HYDROLOGY G19/D9B 2 PLANS

REF: DRAINAGE PLAN FOR PENMONT PLAZA (G19-D9B) RECEIVED OCTOBER 9, 1985

REF: DRAINAGE PLAN FOR PENMONT PLAZA (G19-D9B) RECEIVED AUGUST 30, 1985

PROJECT TITLE: Penmont Plaza ZONE ATLAS/DRNG. FILE #: G-19-Z09B

Exhibit Map B

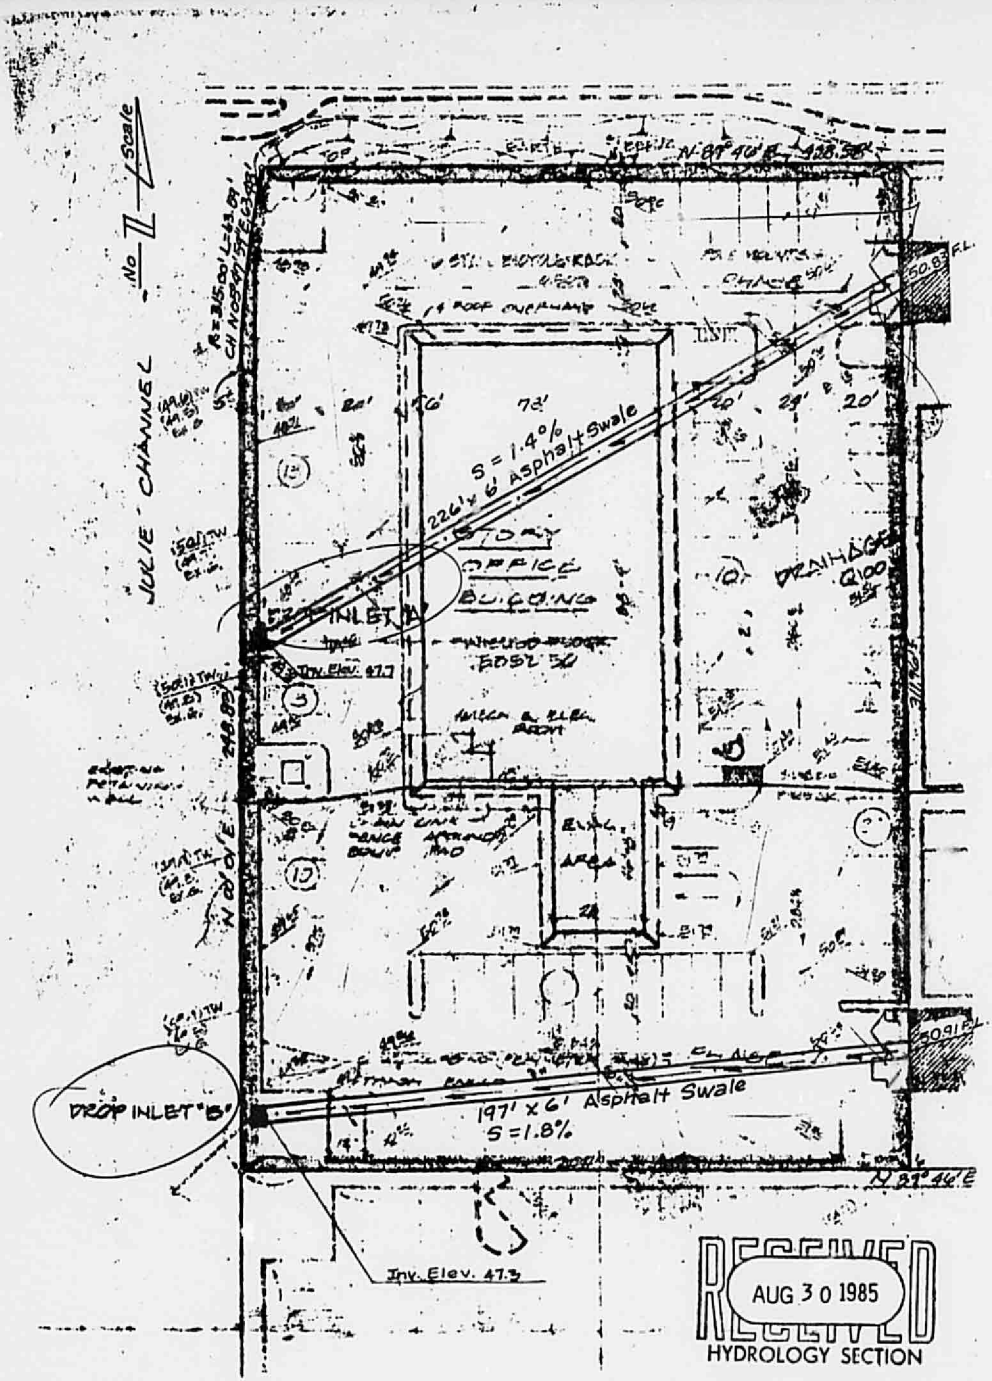
2. Require written concurrence from the owners of Tract A-4-1A that the interim asphalt swales are acceptable. Address who will maintain this interim system.

3. Please address when Tract A-4-1A will be developed. Also, address where the flows will be directed once Tract A-4-2A is developed. This permanent solution for the conveyance of flows accross Tract A-4-1A requires a drainage easement.

Item No. 2: Interim swales will no longer be necessary since the State Farm Insurance Building to the west will be constructed prior to our project.

Exhibit Map A, taken from dwg. by Gardner, Mason & Assoc. on file w/ City - Master Drainage Plan, G19, D-9

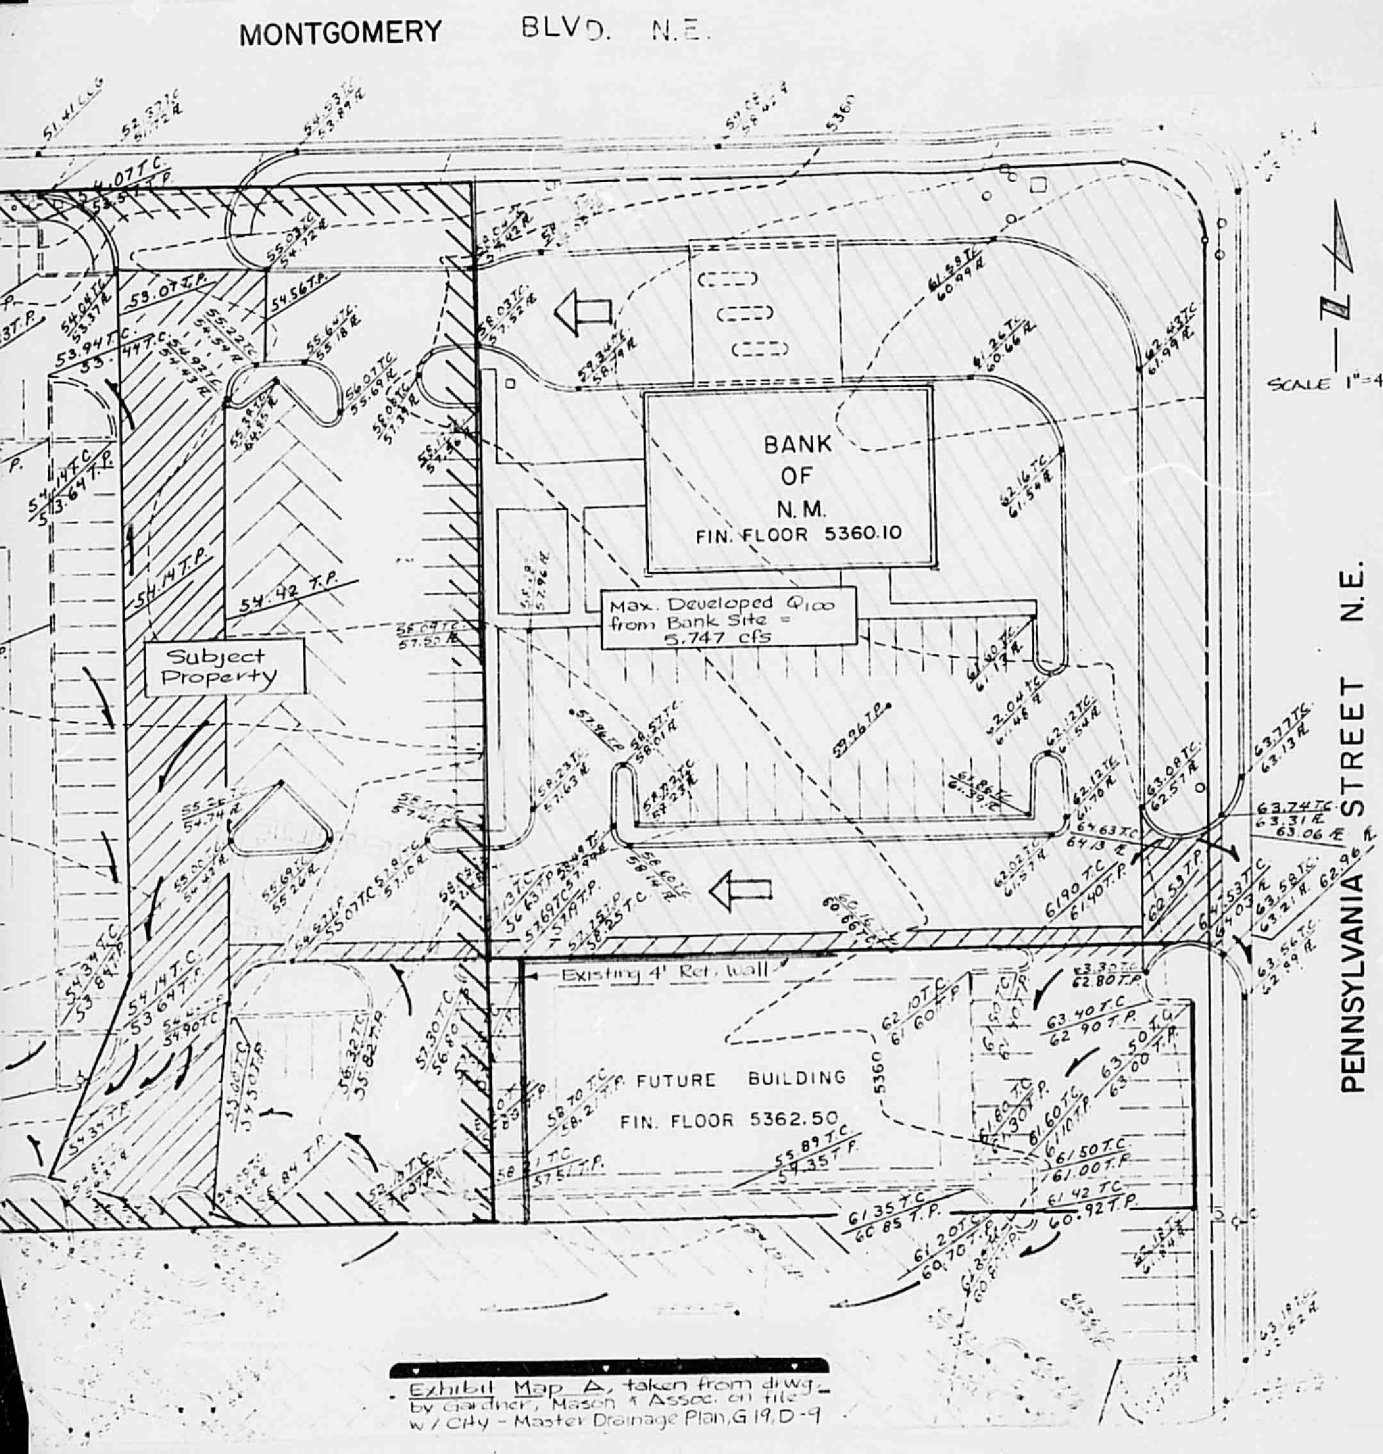
4. Please address if drop inlets "A" & "B" are built. Please show hydraulic calculations which show that these inlets have capacity for the developed basin.

Item No. 4: Drop inlets "A" and "B" are existing inlets. Drop Inlet "A" which is to the north is 18". It has a capacity of 20-22 cfs and will be recieving only 3.03 cfs from Area A_1 as designated on the master drainage plan as referenced in Item No. 3. Drop Inlet "B" which is to the south is 24". It has a capacity of 37-40 cfs and will be recieving only 22.82 cfs from Area A_2 also as referenced on the above mentioned plan.
For the original calculations on sizing the inlets to accomodate the flows for the site , see "Supplement to Storm Drainage Study" by Gardner, Mason & Assoc., dated 1981.
